**Addendum No.:** 3

**Bid#:** 333-00-18-21-2

**Project Name:** Covington Library Renovation

**1 D101 DEMOLITION / REMEDIAL FLOOR PLAN**  
scale 1/8" = 1'-0"

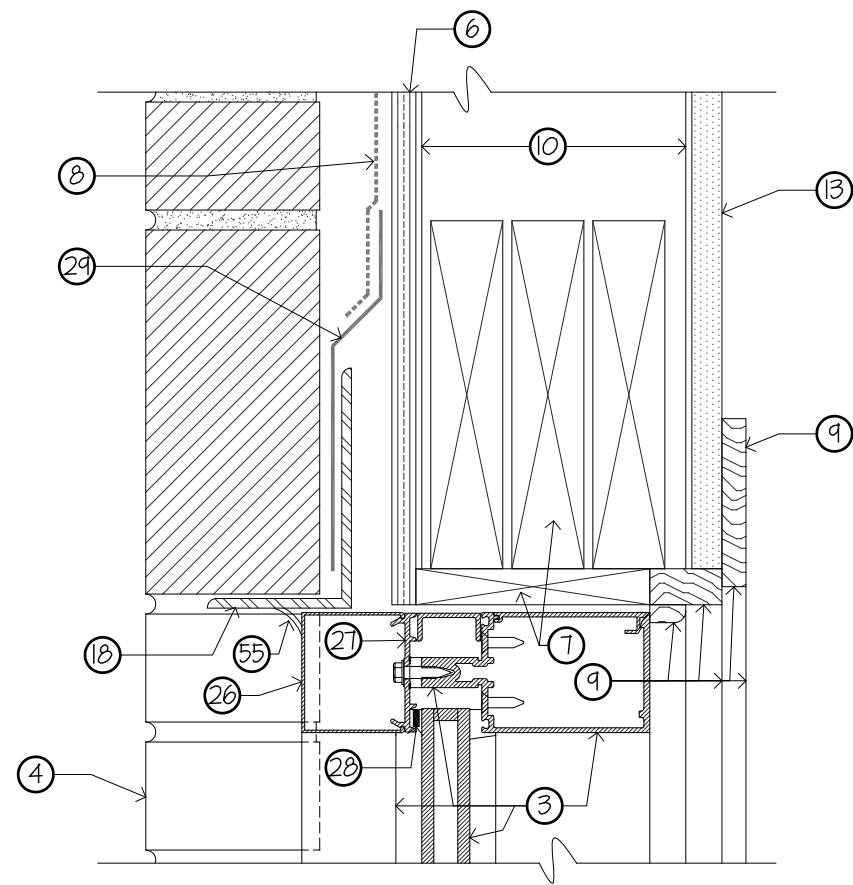
3. Delete Sheet D101 from Section 11 Drawings and replace with revised Sheet D101 (attached). In Detail 1 Demolition / Remedial Floor Plan: Door to Corridor 132 from Meeting Room 139 (indicated as Door Tag 16 on Sheet A101) shall be dashed and called to be removed with frame to remain.

Question #1: “NORTHERN FRAME IN THE GENEALOGY ROOM #104 DOES NOT HAVE ANY FRAME NOR DOOR DESIGNATION. IS IT EXISTING?”

Question #2: “ALSO WESTERLY FRAME AND DOOR OUT OF VESTIBULE #102 AGAIN DOES NOT HAVE ANY DESIGNATION. IS THIS ALSO EXISTING?”

**Answer #1: Per the Demolition/Remedial Floor Plan on Sheet D101, this door and frame are existing.**

**Answer #2: Per the Demolition/Remedial Floor Plan on Sheet D101, this door and frame are existing.**

**7 SILL AXONOMETRIC**  
scale 1-1/2"= 1'-0"

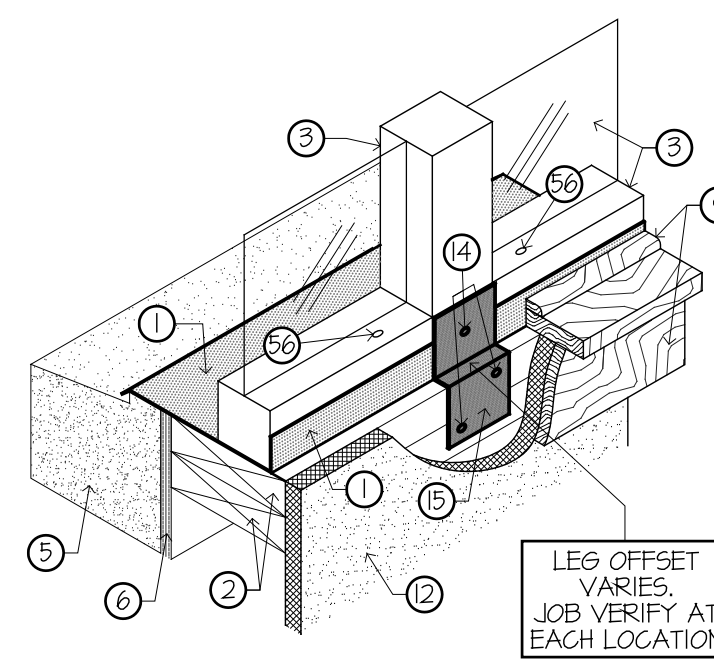
4. Delete Sheet A602 from Section 11 Drawings and replace with the revised Sheet A602 (attached). Key Note 15 was deleted in its entirety and replaced with the following:

Question #10: “After further review of the windows, some concerns were raised. If these questions can be answered, it would help me tremendously in going forward in bidding this job. It appears that the anchors are being removed from the bottom of the curtain wall system. Are we responsible for any engineering/warranty of the this work? The removal of anchors, especially the larger opening, will weaken the wind-load of this system.”

*15. 2-1/2" WIDE 16 GA. STAINLESS STEEL ANCHOR STRAP POWDERCOATED TO MATCH WINDOW TRIM CAP. PROVIDE ANCHOR STRAP AT EVERY VERTICAL FRAMING MEMBER (JAMBS, INTERMEDIATE MULLIONS, ETC.).*
  5. For additional items, see attached letter from GVA Engineering, L.L.C. dated August 7, 2018 (2 pages).

coated stainless steel anchor straps to be anchored at the face of the blocking to maintain wind resistance. See Drawing Items Note 2 above for additional information.
